**RE: Primrose School of Sandia Heights
Conceptual Grading and Drainage Plan
Engineer's Stamp Date: 06/15/18
Hydrology File: D19D030**

**RE: Primrose School of Sandia Heights Hydrology File D19D030
Conceptual Grading and Drainage Resubmittal
Engineer's Stamp Date 06-14-18**

PRIMROSE SCHOOL OF SANDIA HEIGHTS

CONCEPTUAL GRADING & DRAINAGE PLAN

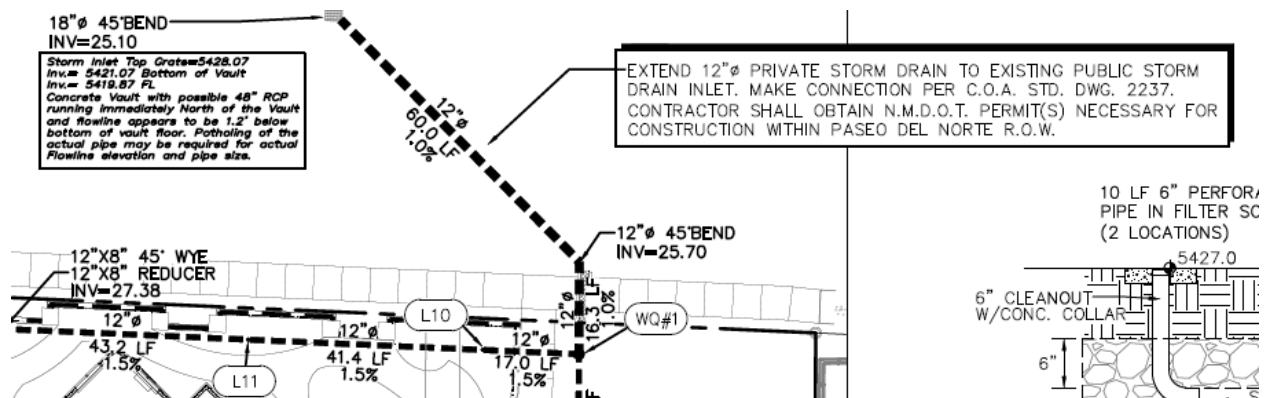
This property, although currently undeveloped, has been used annually for the sale of Christmas trees for many years. The historic discharge rate to the NMDOT storm drain system of 2.7 cfs is based on land treatments of 50%B, 50%C (see Google Earth Images from 2009 and 2012).

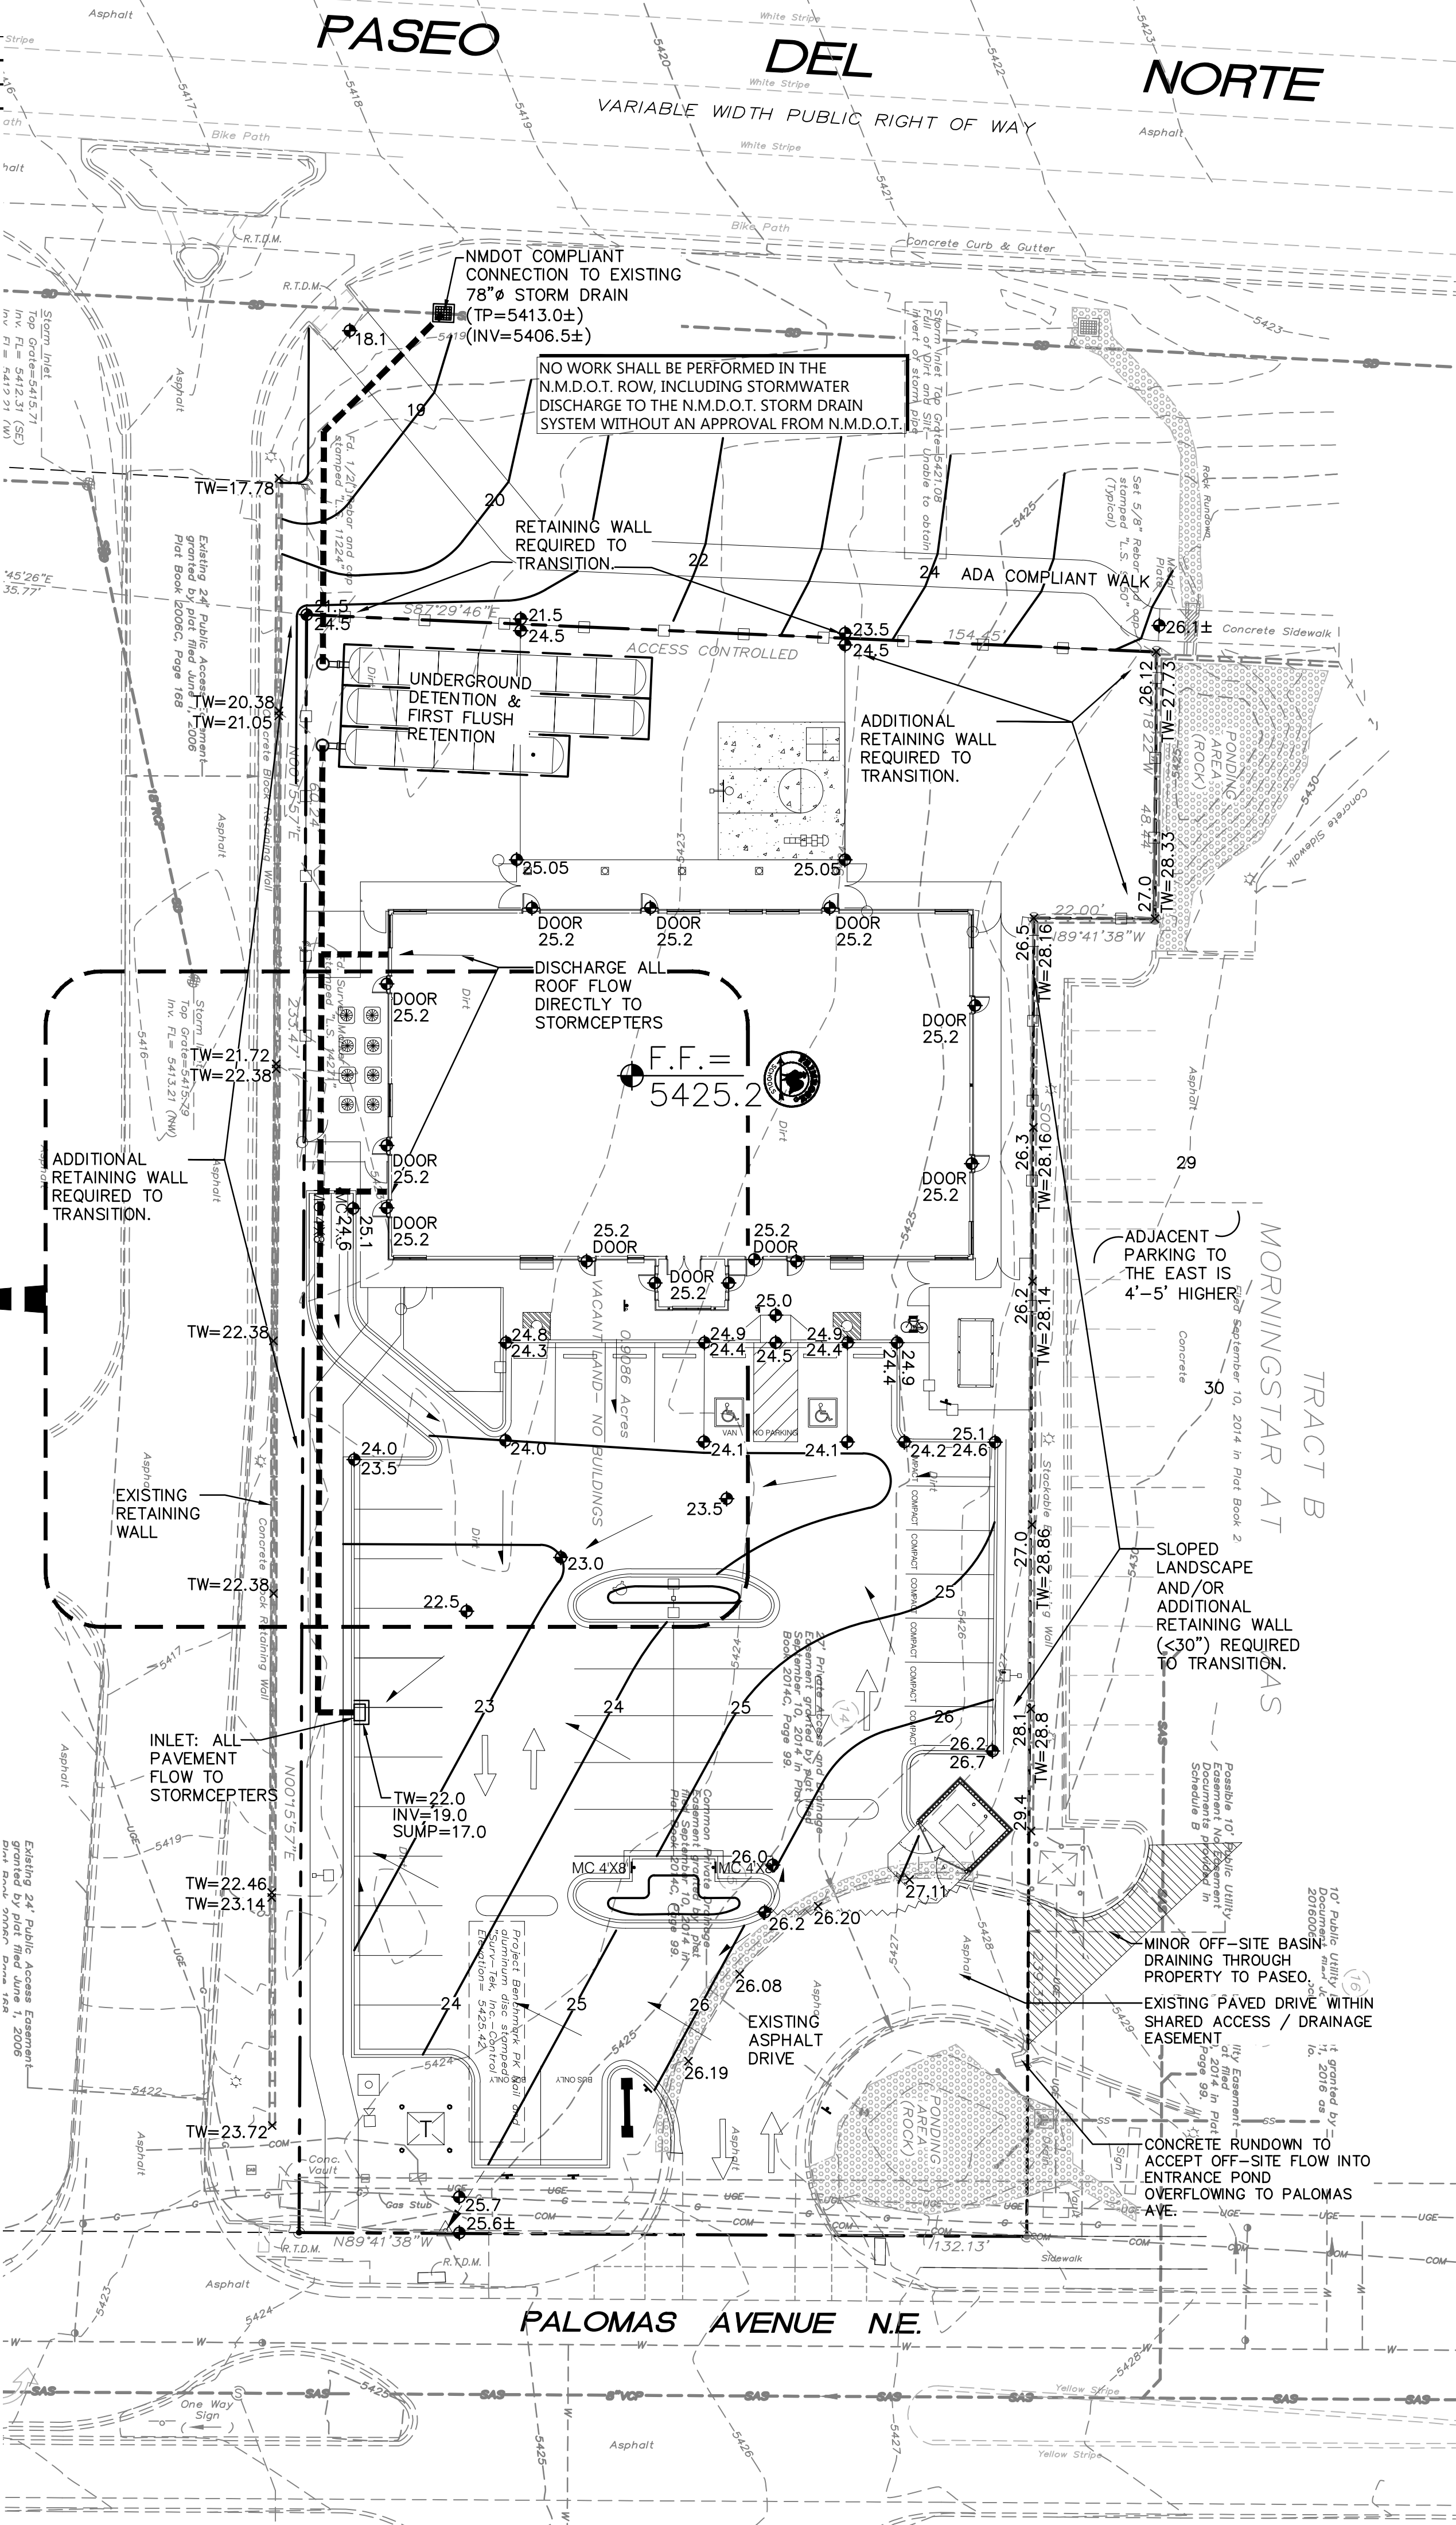
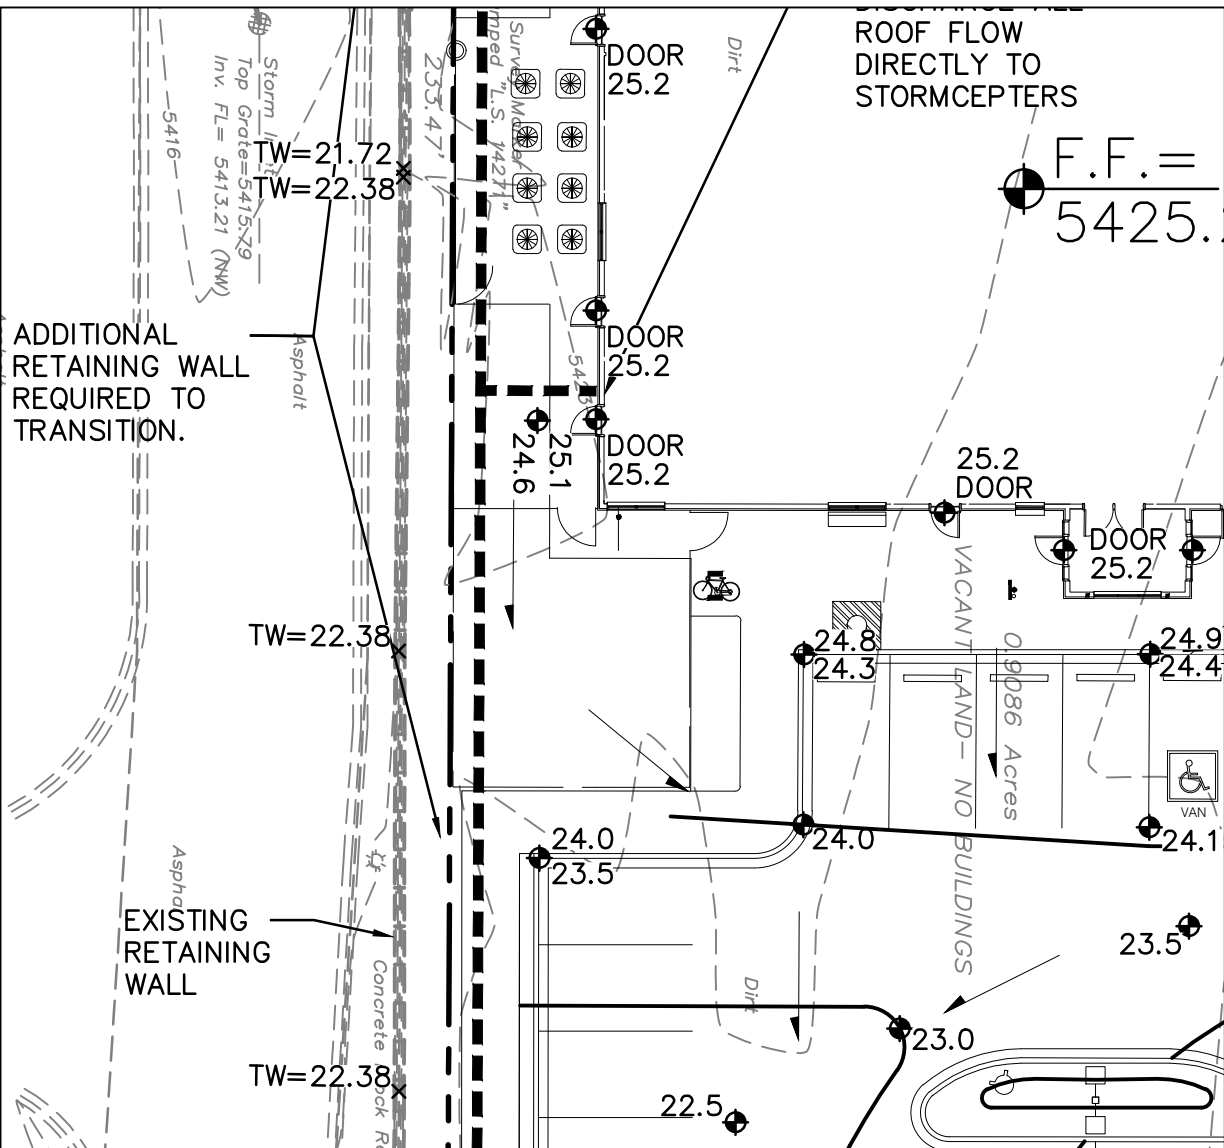
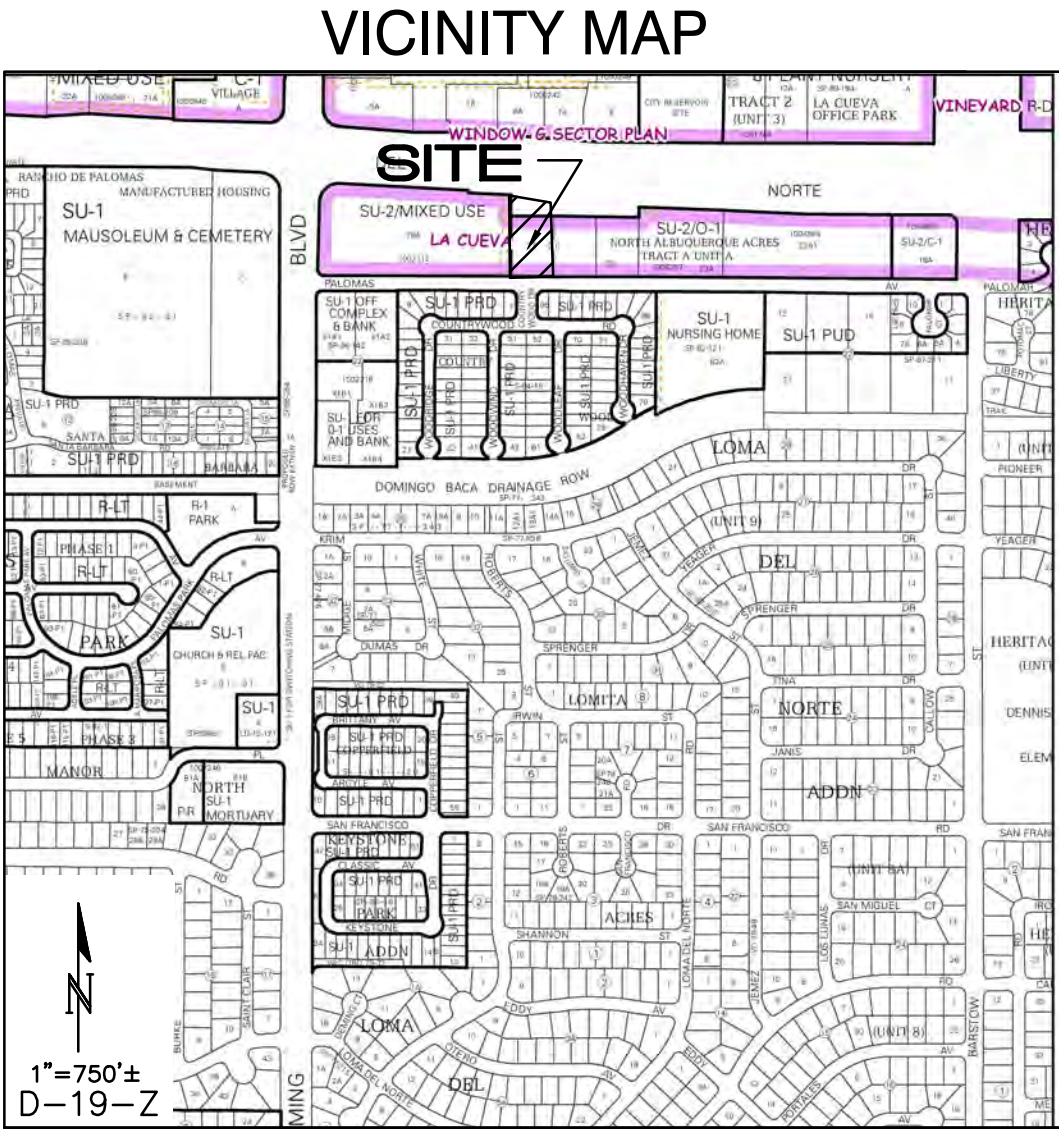
Attached with this letter is the revised Conceptual Grading and Drainage Plan for the above referenced project. Revisions were based on minor site plan changes and in response to your review comments dated February 2, 2018 as follows:

1. Road names added;
2. Existing line work changed to dashed to clearly show the limits of proposed construction;
3. As noted on the plan, based on the *North and South Domingo Baca Arroyos and Paseo Del Norte Corridor Drainage Management Plan* prepared by Resource Technology, Inc. (1991) 100% of the site historically drains to the Paseo del Norte R.O.W. (NMDOT). In the developed condition, the site is permitted to continue to release historic rates either as surface flow or with a new storm drain connection to the NMDOT storm drain system.

BASED ON THE NORTH AND SOUTH DOMINGO BACA ARROYOS AND PASEO DEL NORTE (PDN) CORRIDOR DRAINAGE MANAGEMENT PLAN PREPARED BY RESOURCE TECHNOLOGY, INC. (1991) 100% OF THE SITE HISTORICALLY DRAINS TO PDN.

THIS PROPERTY, ALTHOUGH CURRENTLY UNDEVELOPED, HAS BEEN USED ANNUALLY FOR THE SALE OF CHRISTMAS TREES FOR MANY YEARS (SEE GOOGLE EARTH IMAGES FROM 2009 AND 2012). THE HISTORIC DISCHARGE RATE TO THE PDN STORM DRAIN SYSTEM OF 2.7 CFS IS BASED ON LAND TREATMENTS OF 50%B, 50%C.

NO WORK SHALL BE PERFORMED IN THE N.M.D.O.T. ROW, INCLUDING STORMWATER DISCHARGE TO THE N.M.D.O.T. STORM DRAIN SYSTEM WITHOUT AN APPROVAL FROM N.M.D.O.T.
